# SERVICE BULLETIN 15

Section VIII, Division A  
Service Bulletin  
Issued March 1963

SUBJECT: WESTERN AUTO SUPPLY COMPANY  
Western Auto Imperial Tiller Model 4XC-6390  
Clinton Engine Model 404-0011-081

## SPECIAL WARRANTY INSTRUCTIONS

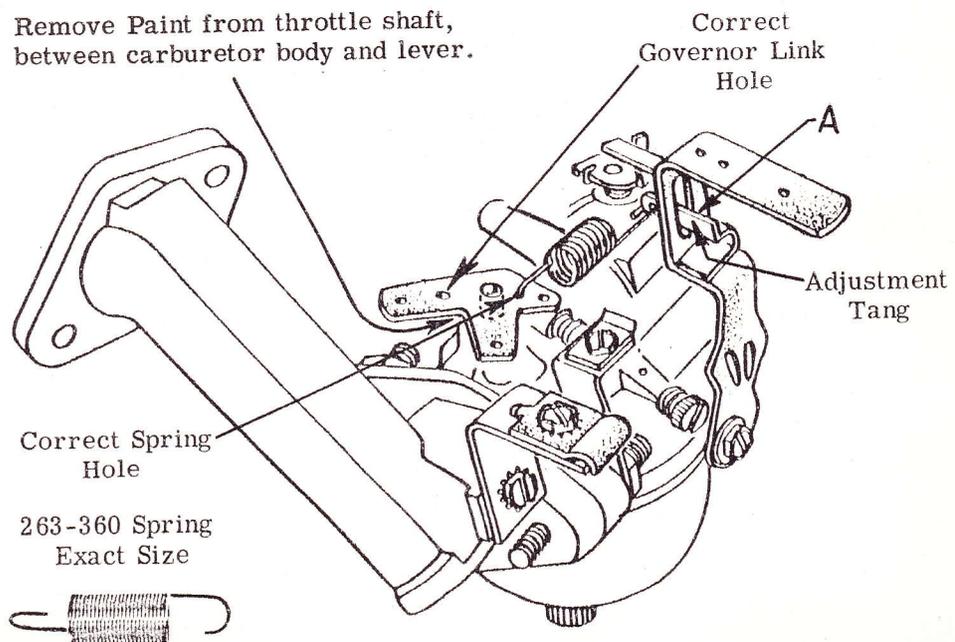
A limited quantity of the above-listed engines (404-0011-081) were shipped from our factory, with governor springs that allowed the no-load operating speed to exceed 3600 R. P. M. In some instances, the spring coils may have been spread apart by factory personnel in an effort to reduce engine speed.

After completing necessary repairs, check the governor spring for correct length, it should be 1-1/8" long, if distorted, too long or too short, replace with a new Part No. 263-360 Spring. Illustrated below is correct hook up of the spring and the governor link, do not deviate.

Point "A" shows the tang that may be bent to adjust maximum no-load speed to 3,600 RPM. Check remote control cable to allow full choking and engine shut-off.

Excessive paint on throttle shaft may cause it to bind. Remove paint to allow free movement of shaft.
